Access Report

**Change of Use**  
**Dwelling to Medical Suites**  
17 Young Street  
EAST MAITLAND

For: Louise Holmes  
Ref: LP\_22005

Development application documentation for the proposed Change of Use from a Dwelling to Medical Suites located at 17 Young Street East Maitland, has been reviewed against current accessibility legislation.

Figure 2 | Overall Site Plan

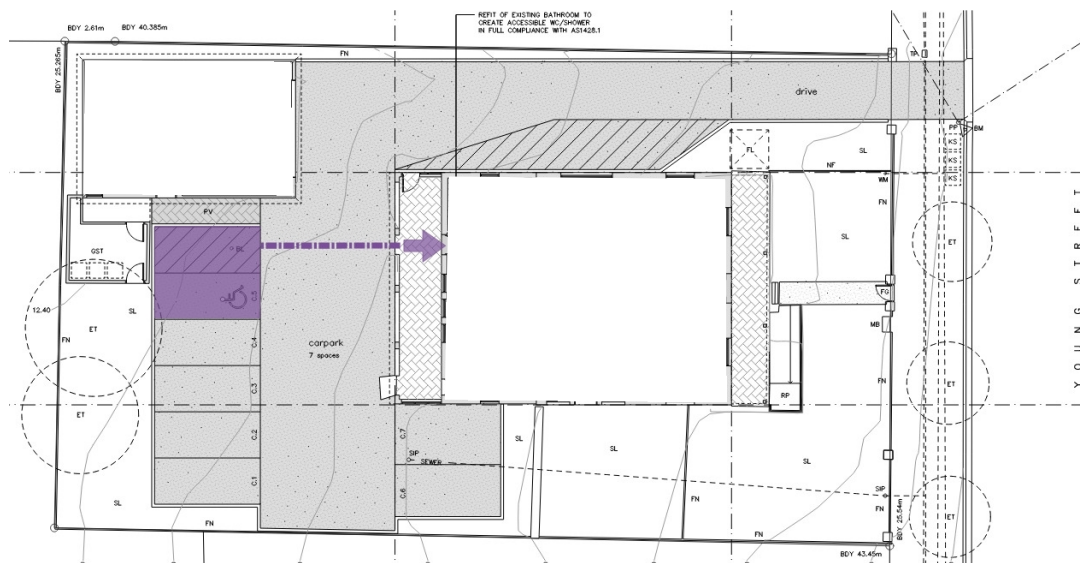
An accessible path of travel is achievable from the accessible carparking space at the rear of the building to the accessible entrance. We have been advised that the car parking levels will be finalized based on achieving access to the building / rear verandah.

Carparking is provided at the rear of the existing building. Plans indicate a total of seven (7) carparking spaces including one (1) accessible space. Therefore, the number of accessible spaces provides BCA compliance.

The overall configuration of the accessible carparking achieves compliance with current legislation including. Ensure the provision of a bollard to the shared area.
